## Request for Class II Permissive Change(C2PC)

FCC ID: VG8EM925AYYGEW2

This is a C2PC application for which the previous grant was issued on 2022-06-13.

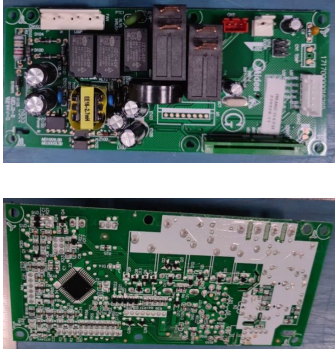
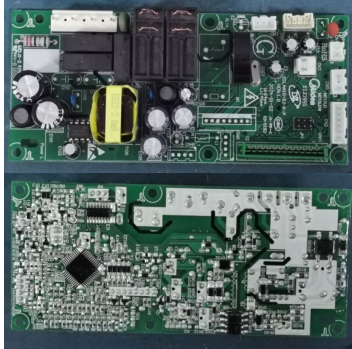
No.:	Original	New	Difference(s)
1			Keypad: Updated front keypad to accommodate child lock function (Child resistant oven door function).
2			Mother board: Modified the peripheral circuit (non-RF circuit) and some individual components and PCB layout. The magnetron and other circuit are exactly same as before.
3	Not Applicable		The new one adds a solenoid valve locking mechanism, the original is not.
